The Commission has issued the enclosed Amendments Nos. 33 and 32 to Facility Operating Licenses Nos. DPR-32 and DPR-37 for the Surry Power Station Units Nos. 1 and 2, respectively. These amendments consist of changes to the Technical Specifications for each license in response to your application dated September 9, 1977, as supplemented September 30 and October 6, 1977.

These amendments relate to the replacement of 81 of the 157 fuel assemblies in the reactor core of Surry Unit No. 2 constituting refueling of the core for fourth cycle operation.

SUPPORTING AMENDMENTS NOS. 33 AND 32 TO LICENSES NOS. DPR-32 AND DPR-37

SURRY POWER STATION UNITS NOS. 1 AND 2

FIGURE 3.12-1B CONTROL BANK INSERTION LIMITS FOR NORMAL 3 LOOP OPERATION - UNIT 2

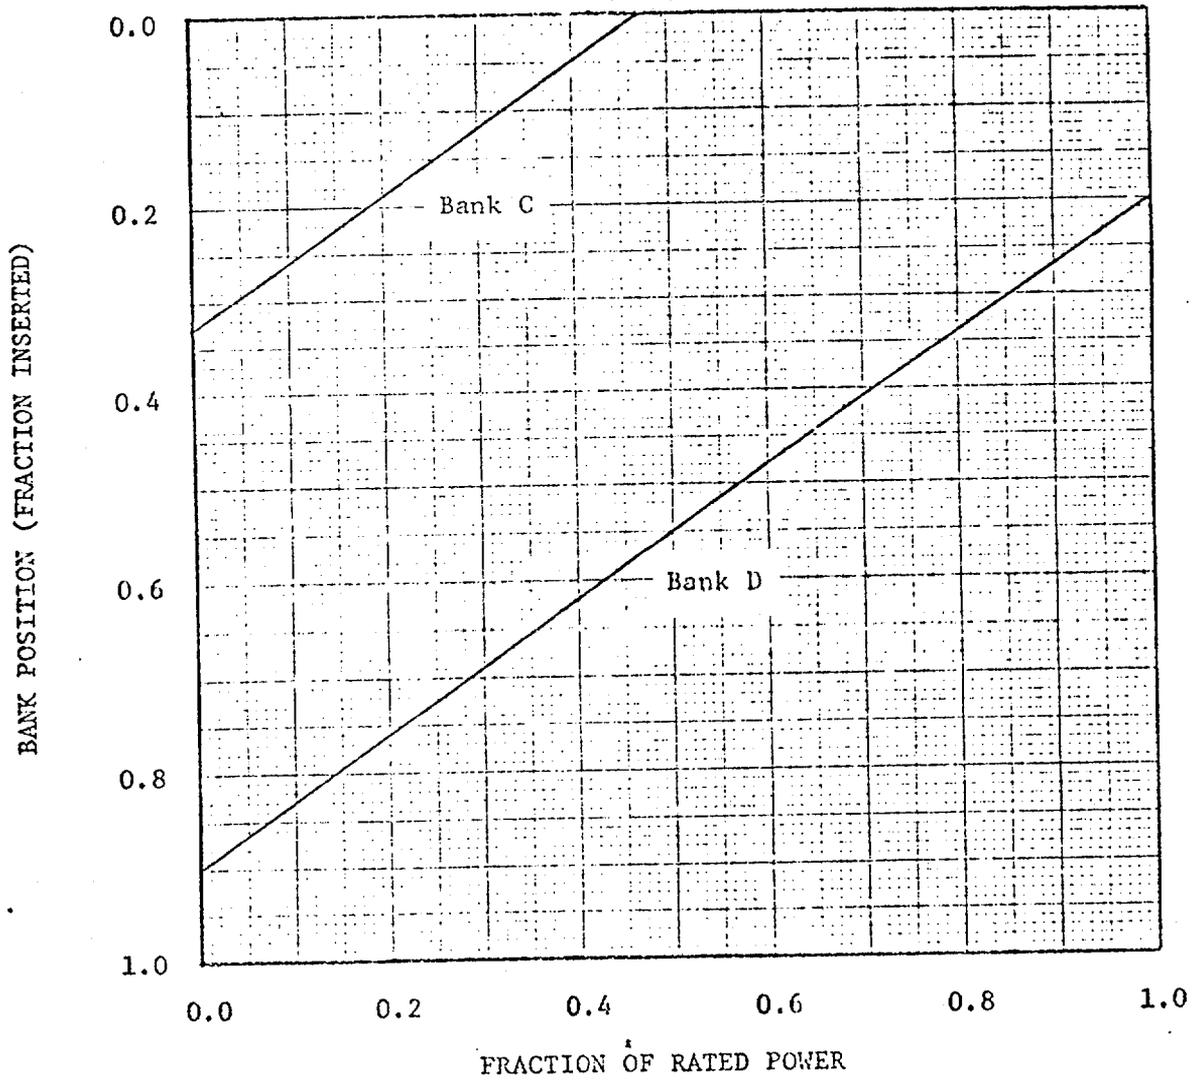
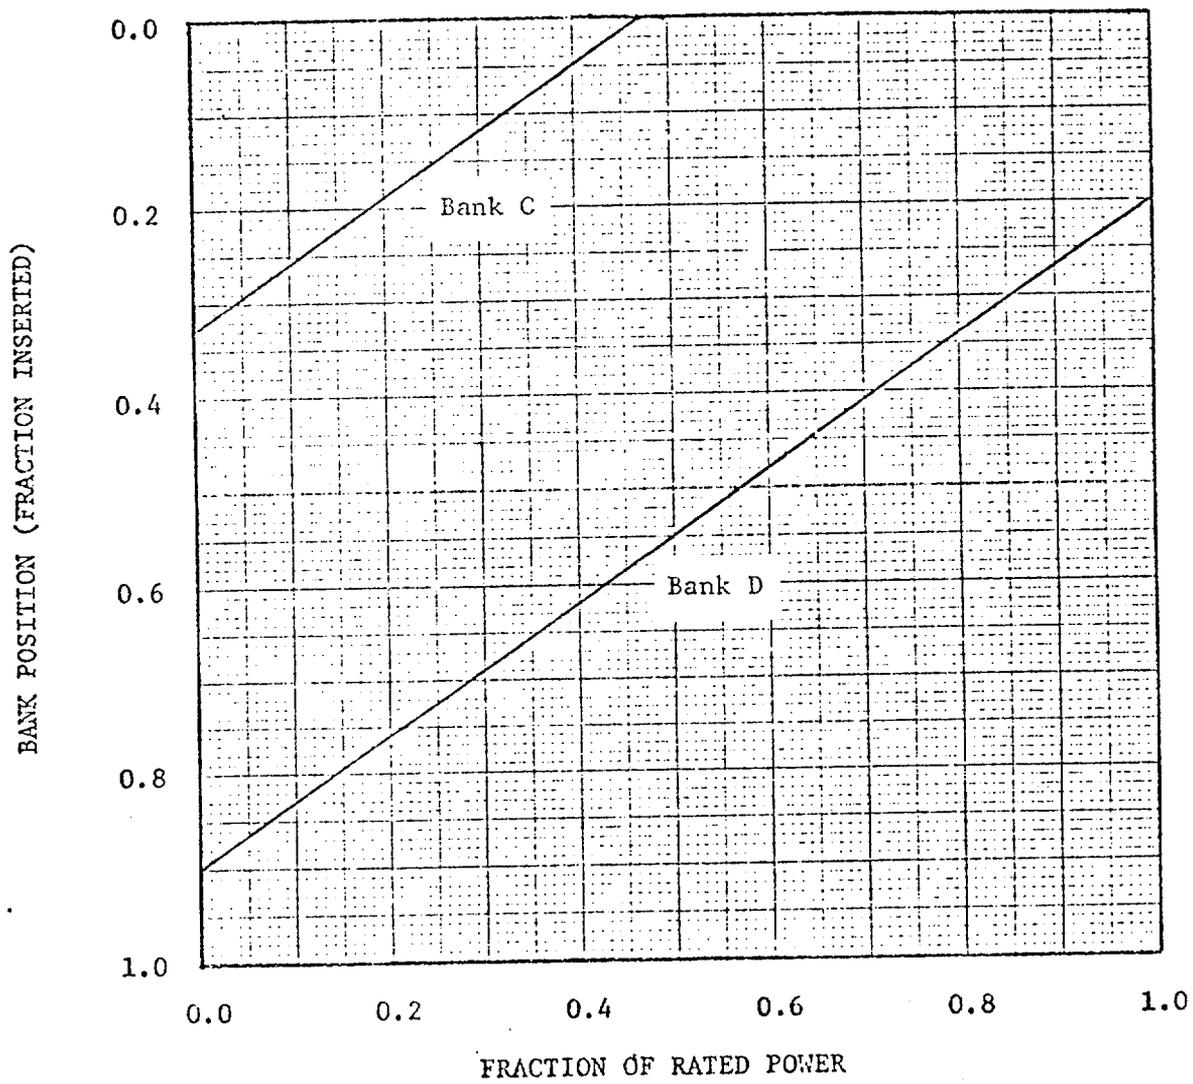
Control Rod Insertion Limits (T.S. Figure 3.12-1B)

The Power Dependent Insertion Limits (PDIL) proposed for Unit 2 cycle 4 are identical to those used for Unit 2 cycle 3. They were generated for Unit 2 cycle 3 assuming a cycle 2 burnup greater than 8700 MWD/MTU.

1. Shutdown Margin
2. Operating statepoints assumed in rod ejection.
3. Values of limiting enthalpy rise.
4. Consequences of misaligned rod.
5. Consequences of uncontrolled rod withdrawal.

The PDIL was reviewed by the licensee to ensure that these criteria were met. It was concluded by the licensee that inputs to the cycle 3 PDIL analysis bounded the corresponding input parameters for cycle 4, and that the cycle 3 PDIL is adequate for cycle 4.

The staff concludes that since the licensee's analysis falls within the bounds of previously approved analyses the PDIL is acceptable.
